Terex Utilities

SAFETY NOTICE

SN-611-14

SUBJECT: *Muncie PTO switch leakage on Ford 6.8L Gas engines*

Switch to inspect for leakage

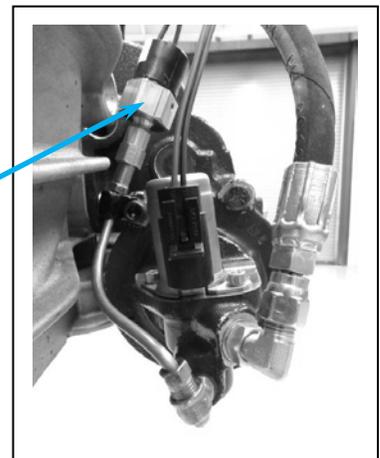
Immediately inspect affected vehicles for any oil leakage from the PTO switch and the condition of the thermal blanket around the exhaust pipe in front of and below the PTO. If the switch is leaking immediately remove the vehicle from service and replace the switch. Also inspect the thermal blanket around the exhaust pipe in front of and below the PTO for damage. Replace the thermal blanket if damaged.

Note: The PTO is located on the side of the transmission. The switch is located on the front of the PTO.

If there is no visible leakage and the thermal blanket is in good condition the vehicle can be used provided the switch is inspected for leaks weekly. Install the Switch Kit at the next service interval, not to exceed 90 days.

If any leakage is detected do not operate the vehicle and replace the switch immediately. Contact your nearest Muncie Power Products Dealer or call Terex Utilities at the contact information below.
